UNITED STATES PATENT AND TRADEMARK OFFICE

APPLICATION NO.	FILING DATE	FIRST NAMED INVENTOR	ATTORNEY DOCKET NO.	CONFIRMATION NO.
09/836,545	04/18/2001	Shinpei Okajima	SN-US015055	6824

<b>Office Action Summary</b>	Application No.	Applicant(s)
	09/836,545	OKAJIMA, SHINPEI
	Examiner	Art Unit
	Melody M. Burch	3683

## DETAILED ACTION

FIG. 3

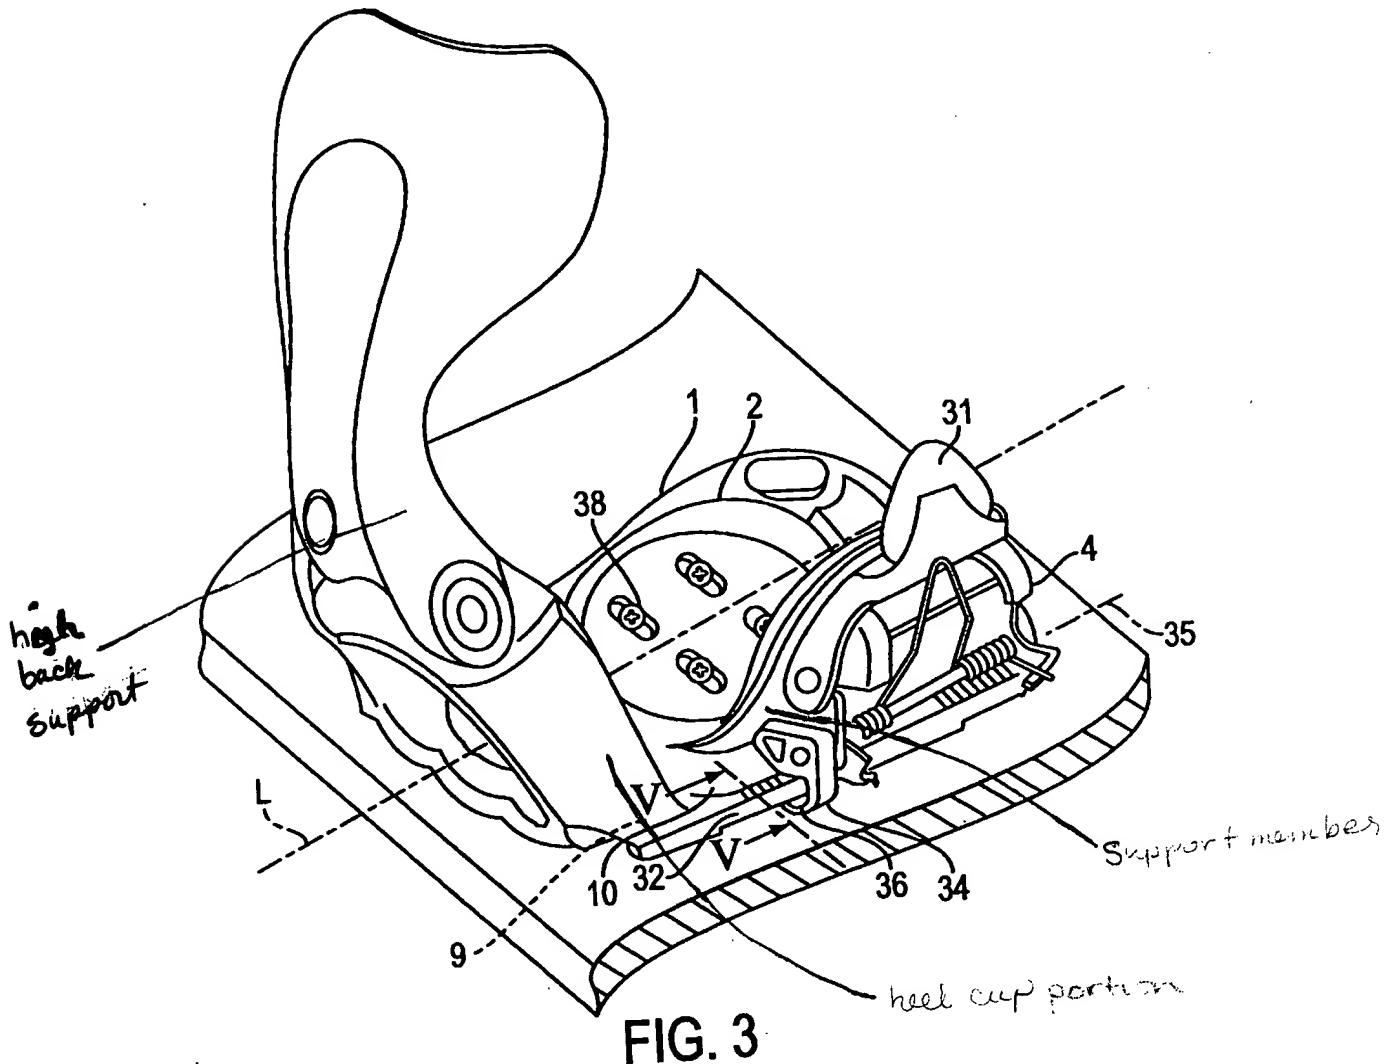
the support members being part of a heel cup with a high back support. Couderc teaches in figure 3 the use of a binding member 4,31 mounted on a support member (which extends outwardly and upwardly relative to the base 1) as labeled in the attached copy of figure 3 of Couderc, the support member being part of a heel cup since the heel cup portion shown in the copy of figure 3 forms a part of element 1 which is a part of element 2 on which the labeled support member is found with a labeled highback support mounted thereto. It would have been obvious to one of ordinary skill in the art at the time the invention was made to have modified the construction of the heel cup and the base of Laughlin et al. '354 to be integral, causing the support members to be a part of the heel cup, as taught by Couderc, in order to reduce the number of parts required in the assembly of the snowboard binding to facilitate manufacturing.
